Facilities Planning and
Development Division

ADDENDUM No. 3
TO THE
CONTRACT DOCUMENTS
NOVEMBER 14, 2025

PROJECT NO. 9558910
DAVIS TOWER #0711/0762 PHARMACY REMODEL

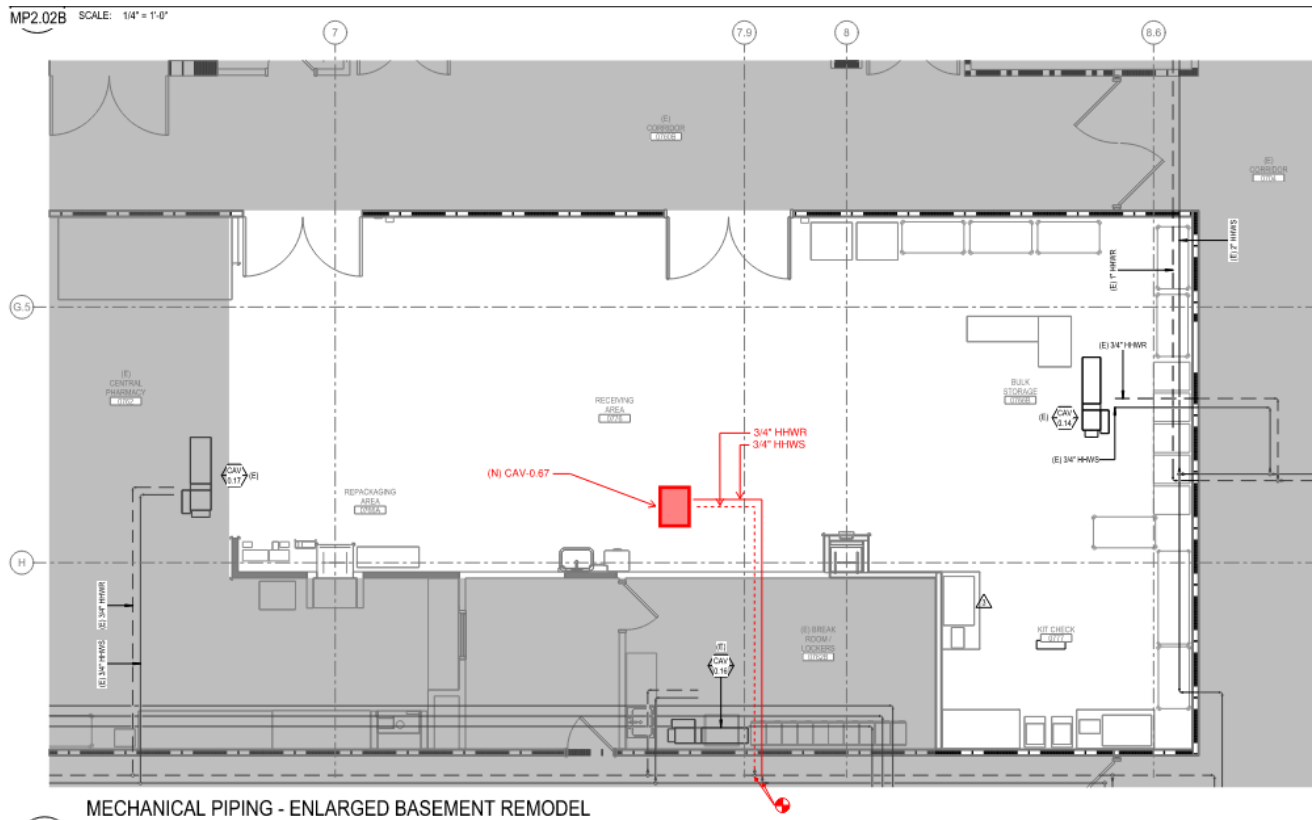
8. **Question:** Plans call out for a new CAV (CAV-0.67) in area that CAV-0.15 is being demolished (see 28 and 30/M2.02B). This does not match up with details on MP2.02B. Mechanical detail 1/MP2.02B shows the demo of the piping, however detail 20/MP2.02B does not show any new piping or the CAV. Please clarify as this specified new CAV-0.67 has a reheat coil.

Answer: Refer to markup below for HHWS/R routing serving CAV-0.67. Sizing is 3/4" HHWS & 3/4" HHWR
